AL HADI PERMANENT POLICE  
STATION  
BASRAH, IRAQ

**SIGIR PA-09-190**  
**APRIL 21, 2010**

SUBJECT: Report on the Al Hadi Permanent Police Station, Basrah, Iraq  
(SIGIR Report Number PA-09-190)

**Figure 3. Conceptual site layout (Courtesy of GRS)**

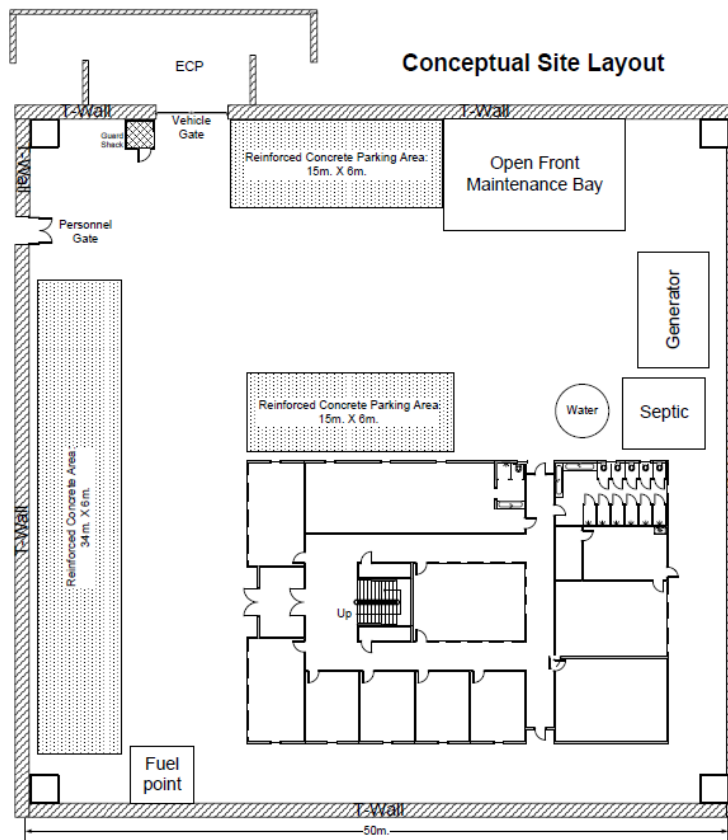
A conceptual site layout was provided with the SOW (Figure 3). The conceptual site layout included all the major items stated in the SOW, and functioned as a guide for the contractor.

Figure 4. Contractor's site design (Courtesy of GRS)

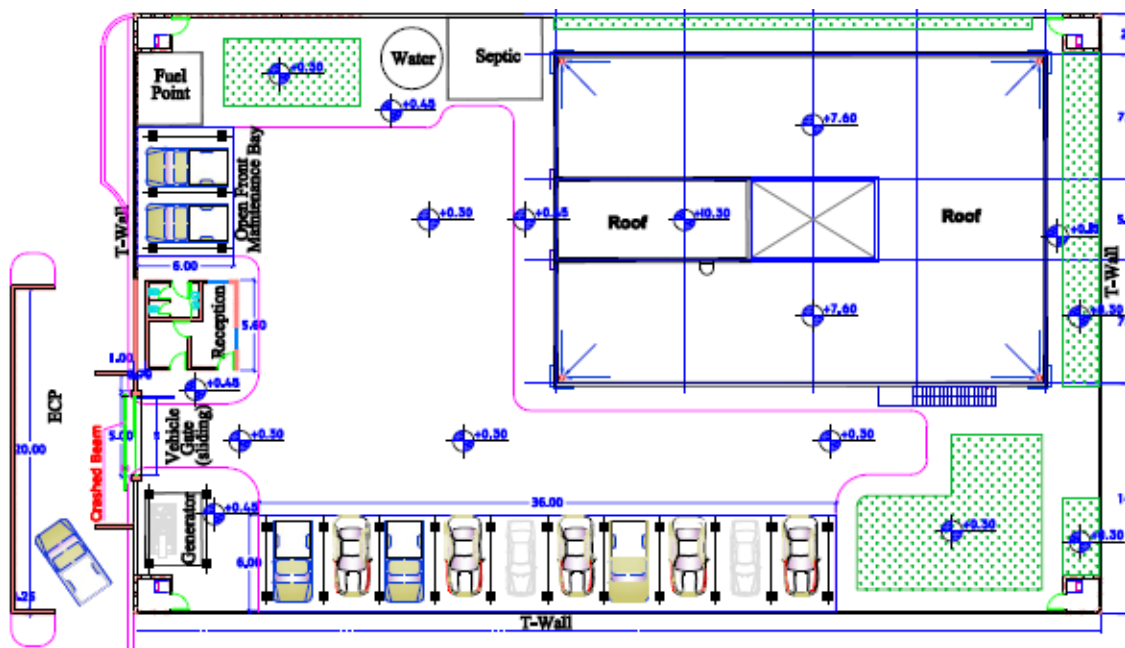
The contractor submitted an actual site plan for the project (Figure 4). The contractor's site plan included all of the items stated in the SOW and accommodated the actual conditions of the project site.

**Figure 5. Non-acceptable and acceptable seismic reinforcing details (Courtesy of GRS)**

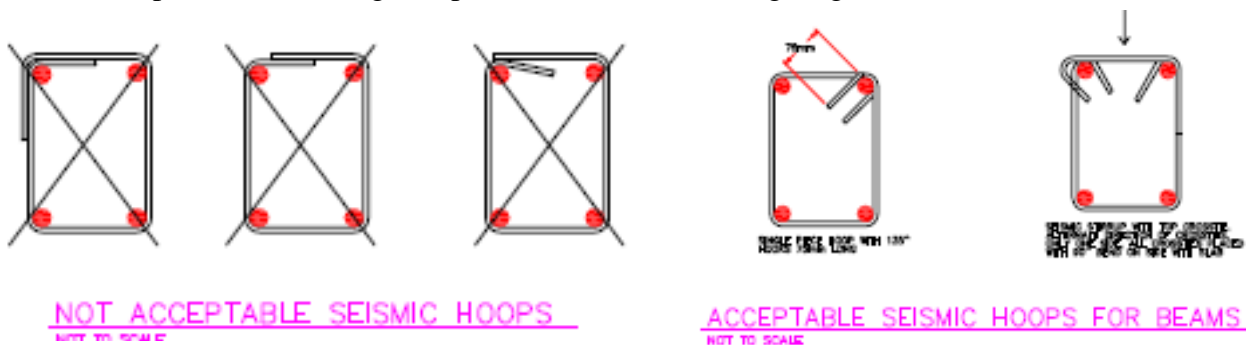
The contractor's structural drawings were included with the project documentation. The structural drawings were comprehensive and included details for construction of the primary structural members. In addition, the drawings provide details for construction of minor elements and clarify areas of the project that could be problematic for construction personnel.

The design drawings included details for the reinforced concrete beams and columns. These details include the typical beam cross section, required primary moment<sup>7</sup> reinforcing, and the shear reinforcing for the reinforced concrete beams. Details are also provided detailing acceptable seismic reinforcing (Figure 5).
